**Device**            **XC835/836MT Series**  
**Marking/Step**   **AB**  
**Package**         **PG-TSSOP-28/DSO-24**

This Errata Sheet describes the deviations from the current user documentation. The module oriented classification and numbering system uses an ascending sequence over several derivatives, including already solved deviations. So gaps inside this enumeration can occur.

**Figure 1 Counting sequence of T12 in center-aligned mode**

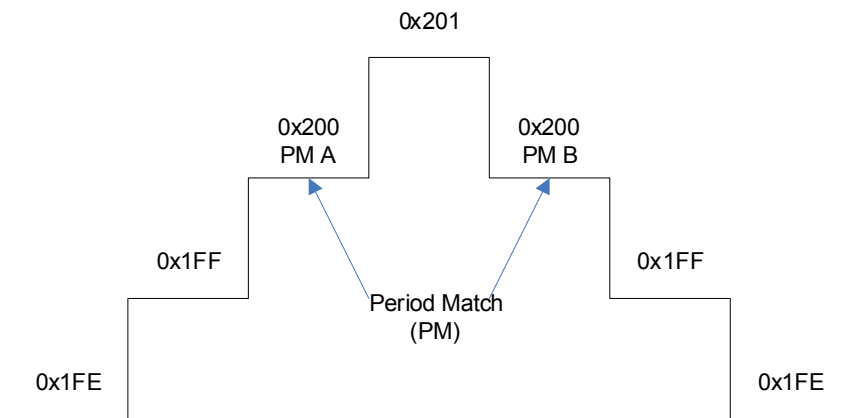
**CCU6\_XC8.H002 CCU6 PM event in center-aligned mode**

After detecting a period match (PM A) in centre-aligned mode, T12 counts down from PM + 1 as shown below:

This means a second PM event (PM B) will occur during the counting down. If ADC is triggered externally via REQTRxC (T12PM), it will be triggered twice in succession. Depending on how real-time the application code is running as well as the T12 count rate and ADC conversion rate, the application could observe two ADC interrupts - once at PM A and once at PM B.

To avoid triggering twice the ADC interrupts, it is suggested to use REQTRxF from multi-channel mode instead of REQTRxC as the trigger source for ADC. Additional initialization are as follows:

- Configure MCMCTR.SWSEL = 101<sub>B</sub> (Transfer on T12 period match)
- Configure MCMCTR.SWSYN = 00<sub>B</sub> (Direct transfer)
- Write to MCMOUTSTL = CF<sub>H</sub> (To enable multi-Channel PWM pattern on CC6x and COUT6x)
